Sensor Actor Line

M12x1 field attachable connectors with hex-nut threaded connection is coming soon

SAL: product change M12x1 field attachable

View of torque wrench

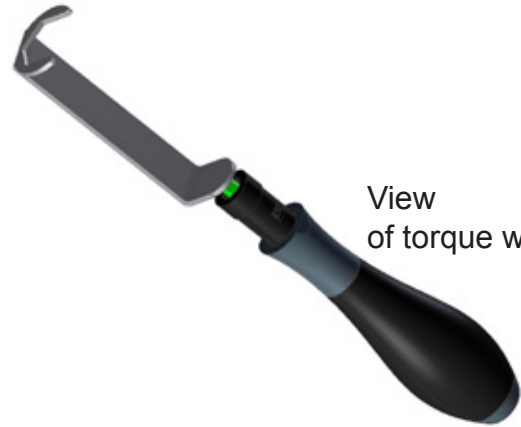
The coupling nut/-screw for the M12x1 field attachable connectors will get a new gripping surface in the form of a WS18 hex-ring at its front end area.

This makes it possible for the user to tighten down the connector to a defined torque even in difficult to reach areas.

The recommended torque is: 0.6Nm.

A special WS18 torque wrench is available for this purpose.
